APPEAL SUMMARY

Appeal ID: 23394

Building/Business Name: Madison High School

LUR or Permit Application No.: 19-116412-CO

1 | SITE PLAN - CODE
A0.30 1" = 50'-0"

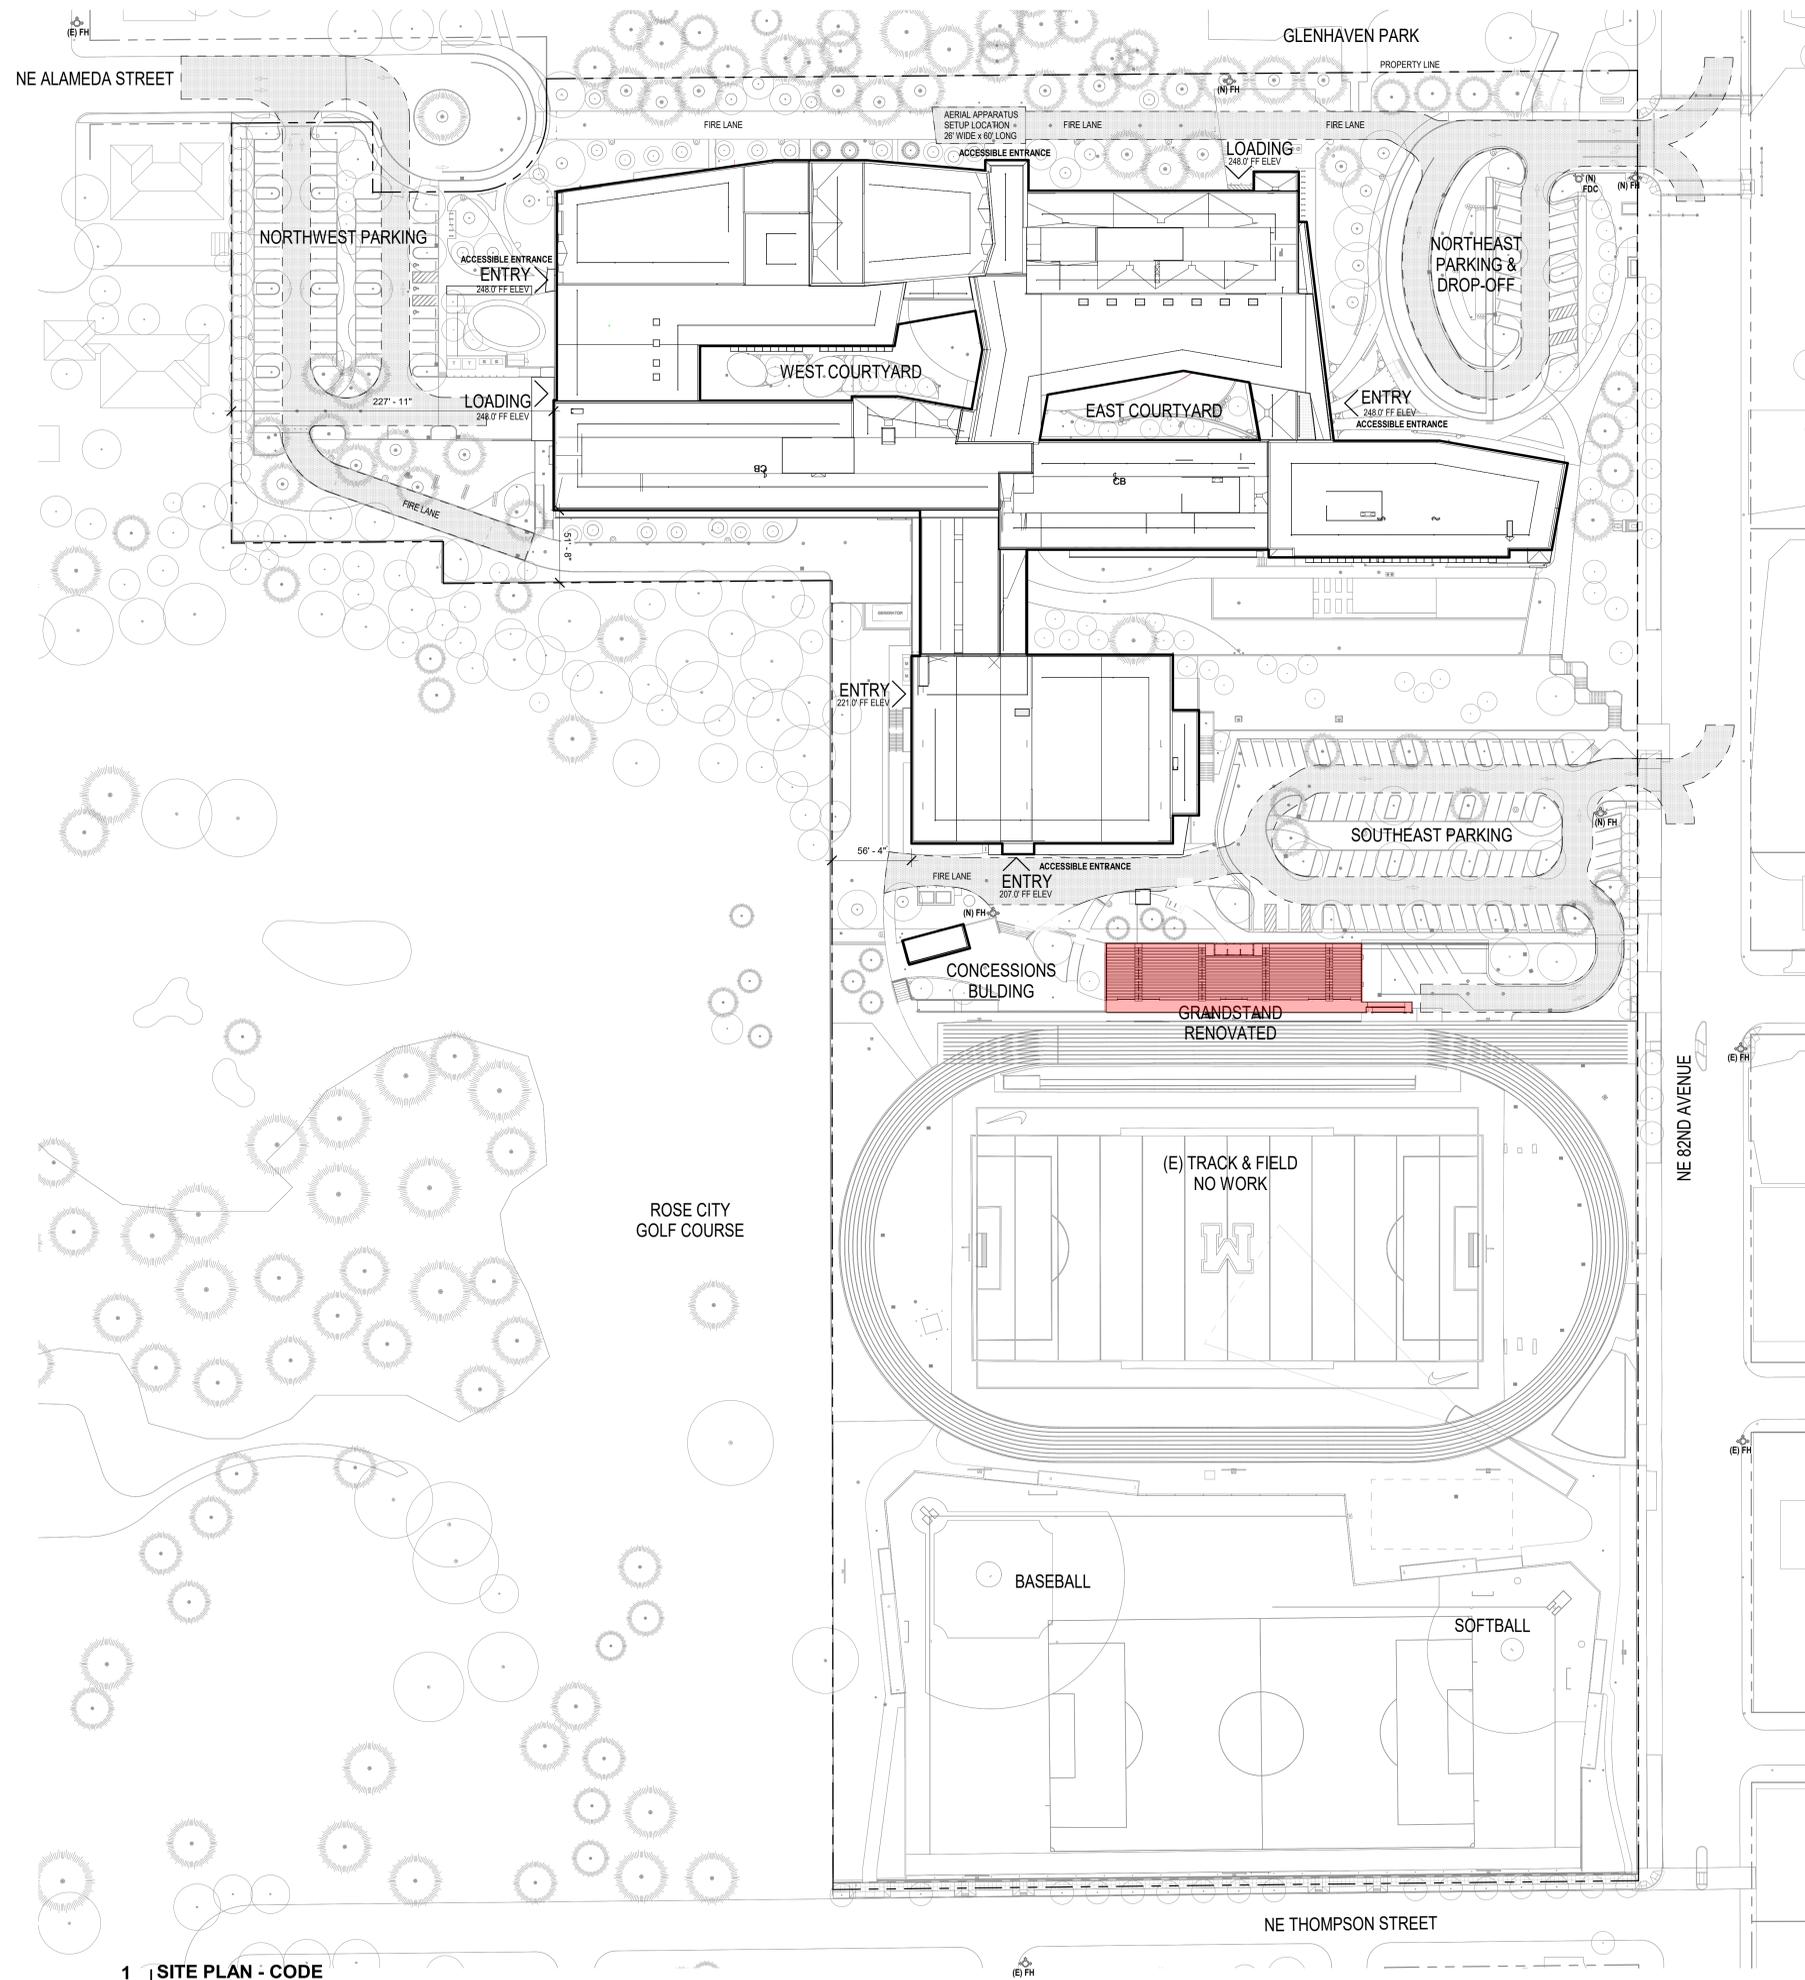
Code Modification or Alternate Requested It is requested that sprinklers be allowed at the storage area below the Grandstands in lieu of a 1-hour fire-resistance-rated separation between the seating above and storage below.

Proposed Design The southern portion of the Madison High School site will include Grandstands positioned to view the track and field for sporting events. The proposed design of the Grandstands includes replacement of the existing structure with a prefabricated aluminum bleacher seating system, including a press box at the top tier. The area below the bleacher seating is partially below grade and will be used as storage. Where it is open to surrounding areas, it will be separated by a solid panel fencing.

Per §1028.1.1.1, a 1-hour fire barrier separation is required between the seating (Group A-5) and the storage (Group S-1). In lieu of a rated assembly, the following is proposed:

- Sprinklers will be provided underneath the Grandstands per NFPA 13.
- A continuous draft stop will be provided at the high side of the Grandstands to act as a heat collector for sprinkler activation. It will be a minimum of 12 inches in height.
- The storage areas underneath the bleachers will be separated by non-rated solid barriers such that each no storage area exceeds 1,000 sf.

1. Use of sprinklers below grandstands for separation of storage space in lieu of 1 hour fire rated separation: Granted provided notification is provided for the grandstands only with installation per NFPA 72.

Sheet Title
GRANDSTAND AND CONCESSIONS PLAN

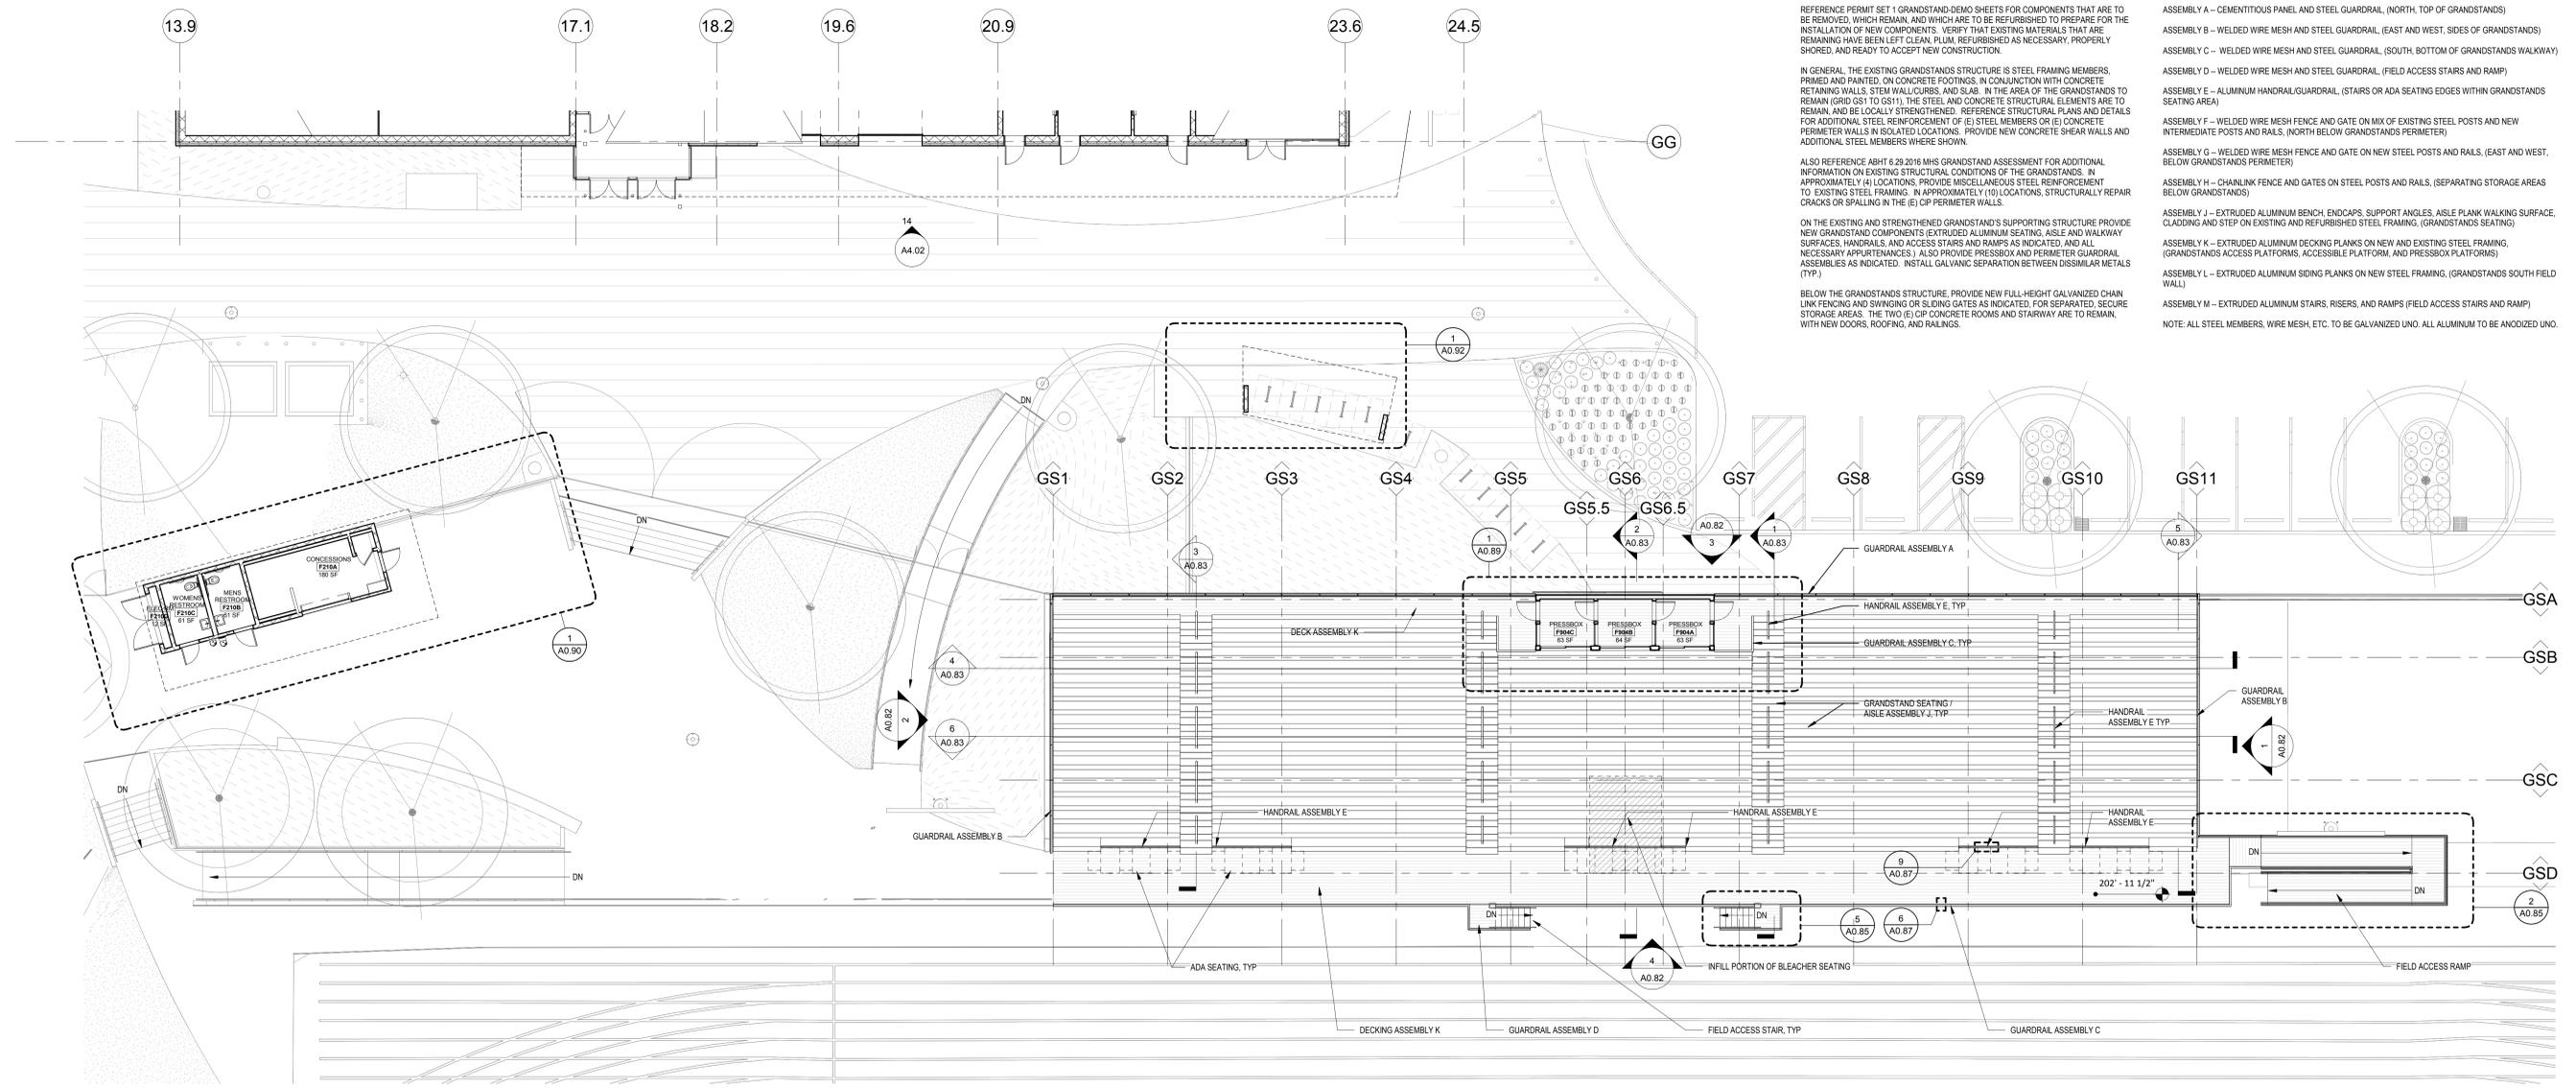
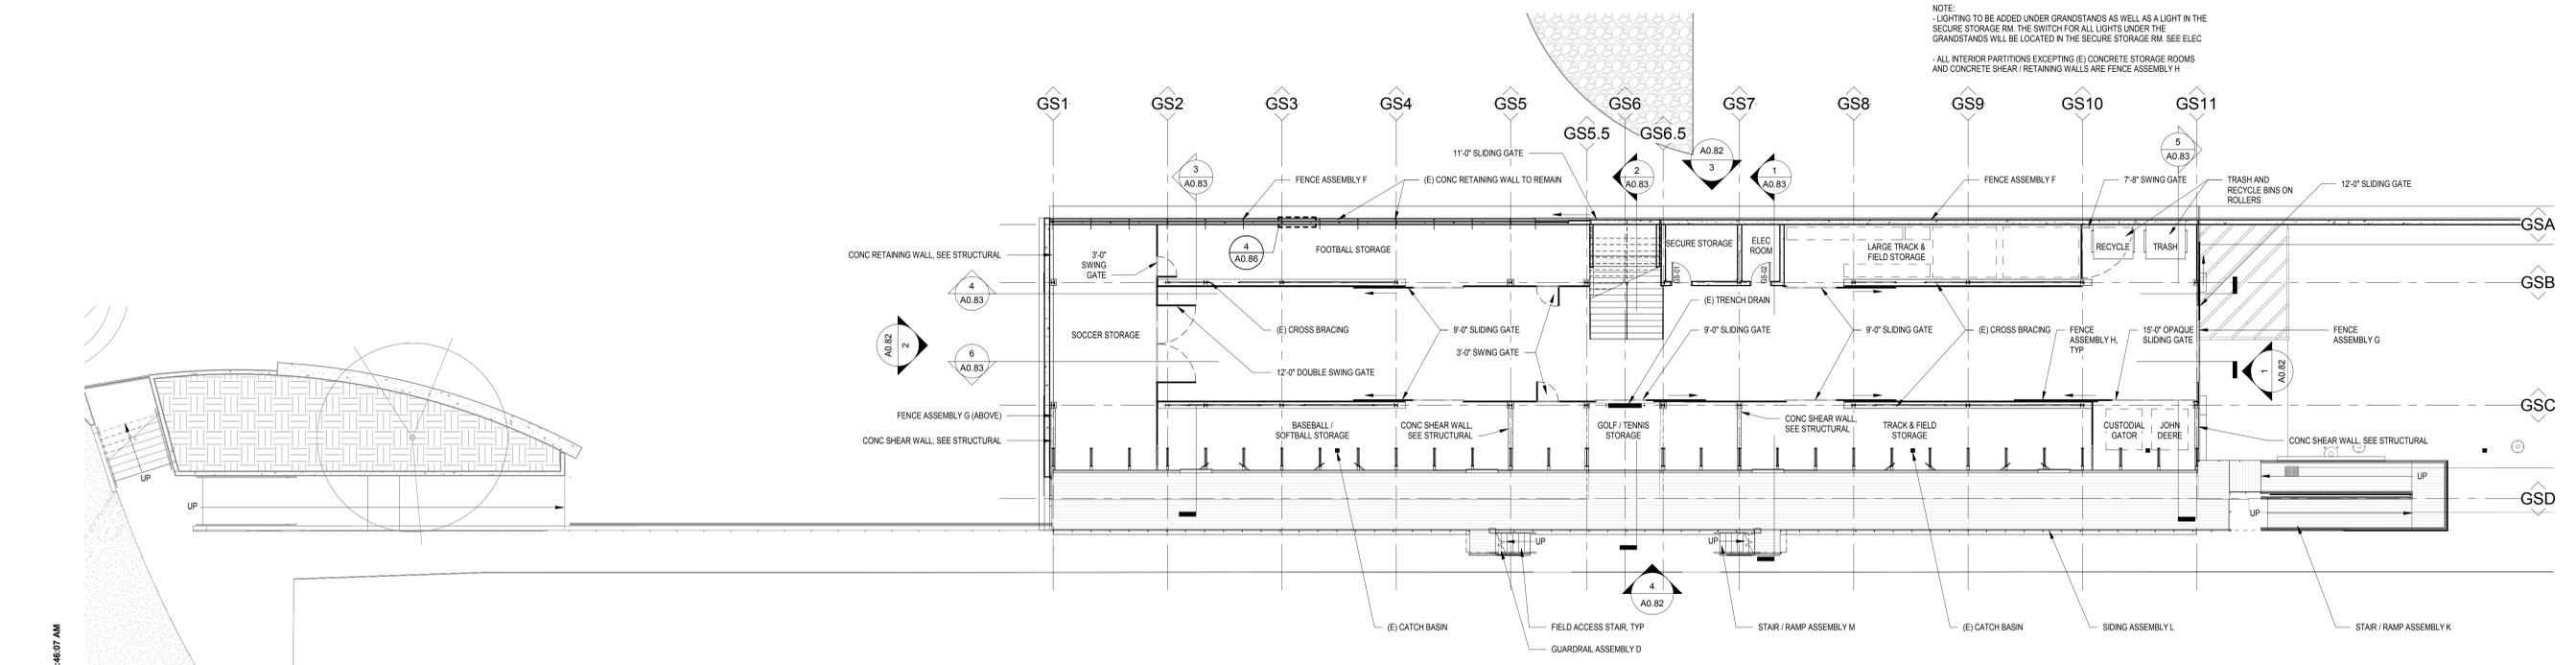
- The trash and recycling area will be separated from the rest of the storage area as an incidental use, meeting the requirements of §509.
